NUCLEAR ENERGY INSTITUTE

**SUBJECT:** Transmittal of Comments on draft Regulatory Guide  
DG-1144 and Revision 1 of MRP-47

**PROJECT NUMBER: 690**

**Comments on  
DRAFT REGULATORY GUIDE DG-1144,  
"GUIDELINES FOR EVALUATING FATIGUE ANALYSES  
INCORPORATING THE LIFE REDUCTION OF METAL COMPONENTS  
DUE TO THE EFFECTS OF THE LIGHT-WATER REACTOR  
ENVIRONMENT FOR NEW REACTORS," JULY 2006.**

Figure 1. Issue of Transient Linking

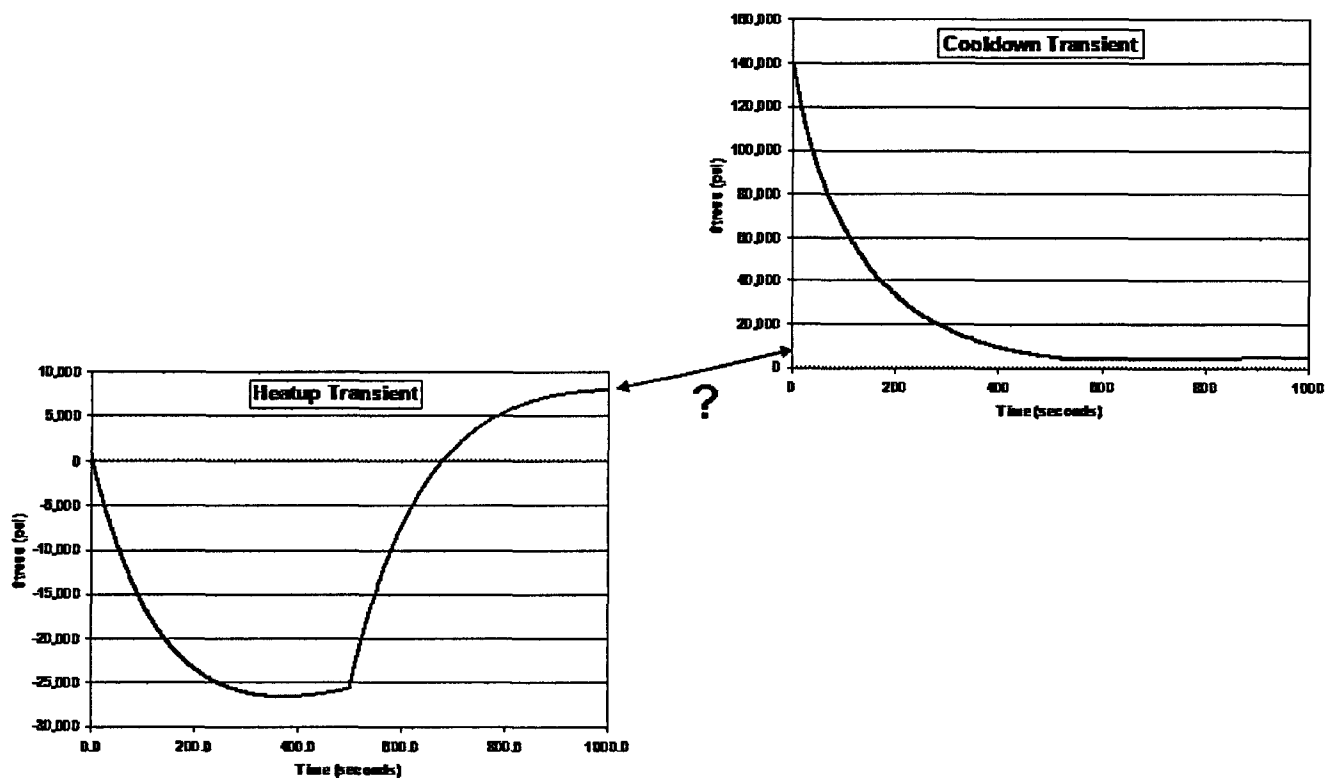
- a. "Linking" of transients pairs is not straight-forward and can lead to significant differences in results (refer to Figure 1). The MRP thinks that the recommendations made in Section 4.2.2 of MRP-47, Rev. 1 are an acceptable means of addressing linking of transients with respect to:
  - Situations where the starting and ending stress points between two linked transients are not equal.
  - Establishing the rate of change for the discontinuity between linked transients.
  - Computing the strain rate for linked transients.

Please revise the text of DG-1144 to state that the recommendations made in Section 4.2.2 of MRP-47, Rev. 1 are an acceptable means of addressing linking of transients, or provide alternate recommendations.
